Planning Proposal – 158 Gorman Road Goulburn (PP-2023-2264; REZ_0003_2324)

I refer to your email of 6 June 2024 requesting pre-gateway comments on a Planning Proposal (dated 5 June 2024) for 158 Gorman Road Goulburn (Lot 11 DP 1044967).

Map 1. Strategic Land and Water Capability Assessment for 158 Gorman Road Goulburn

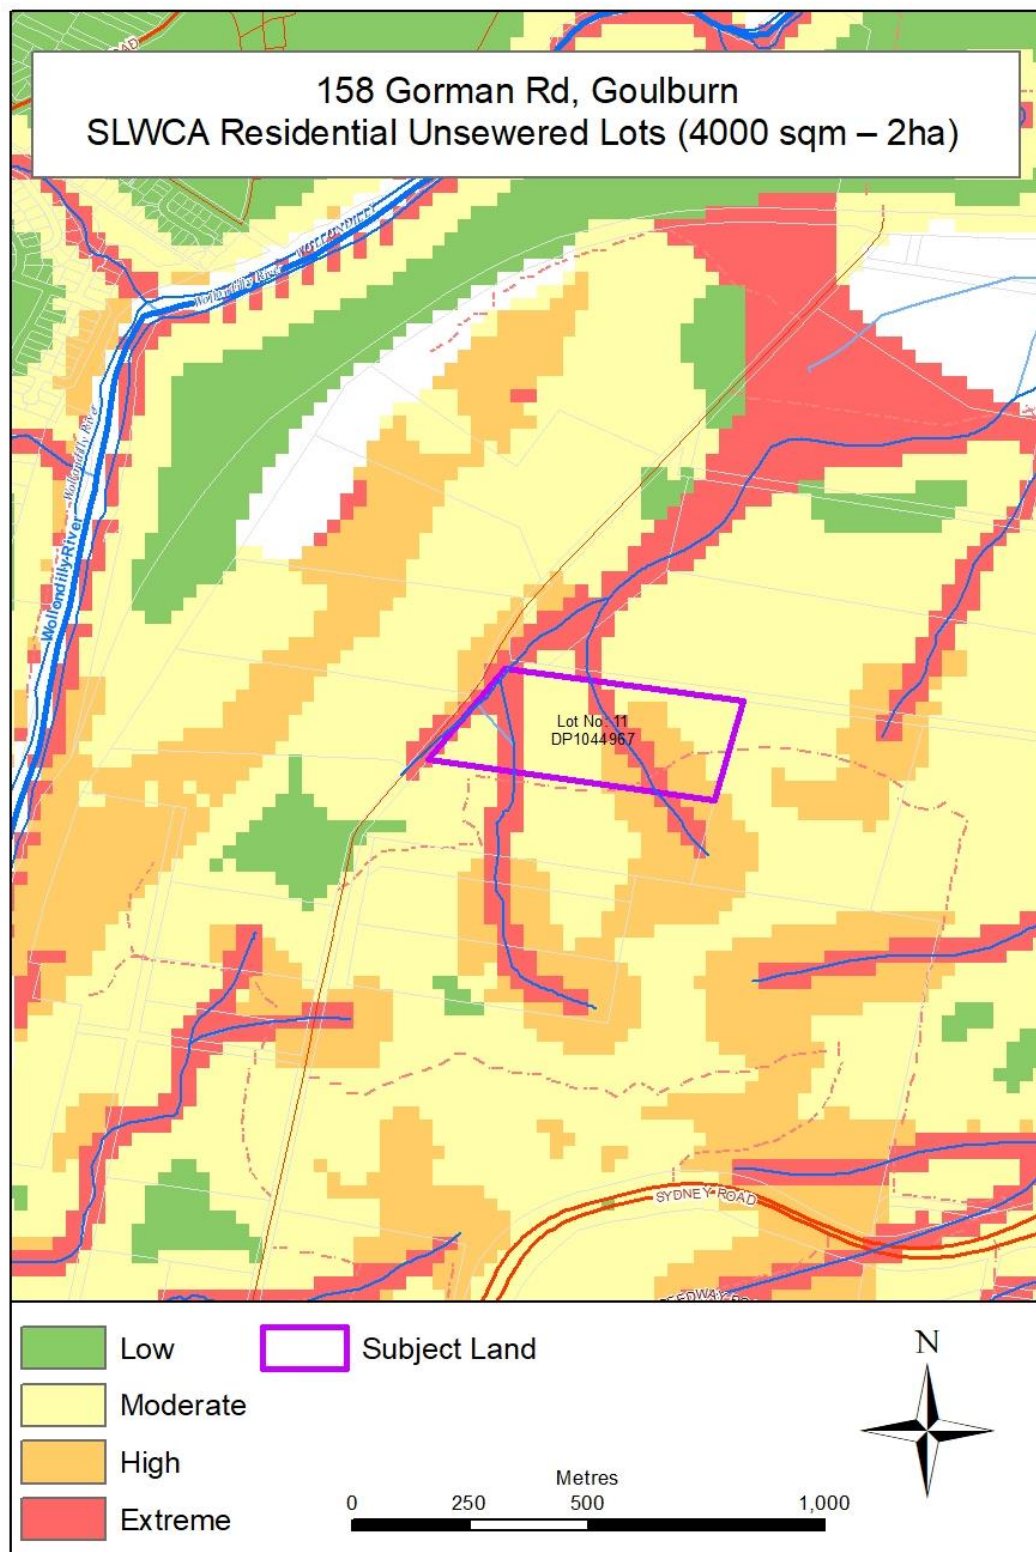
Based on the [NSW hydrography](#) layer, the site is affected by three drainage features. These are shown in the Strategic Land and Water Capability Assessment (SLWCA) we provide in Attachment 2.

We have prepared a Strategic Land and Water Capability Assessment (SLWCA) for the site based on the SLWCA for residential unsewered lots (4000 m² – 2 ha) (See Attachment 2). The SLWCA shows that the water quality risks for the site varies from MODERATE to EXTREME. The areas of EXTREME risk are associated with the drainage features. Areas of EXTREME risk have a VERY LOW capability for the intended use while areas of HIGH risk have a LOW capability. Areas of MODERATE risk have a MODERATE capability for the intended use. Areas of MODERATE risk are generally confined to the proposed R5 zoned land although the R5 area also contains areas of HIGH and EXTREME risk which should be avoided. There appears to be sufficient areas of MODERATE risk accommodate rural residential use of the land at the 2 ha MLS envisaged. Please note that the SLWCA does not take into account the flooding risk from riverine flooding or overland flows.
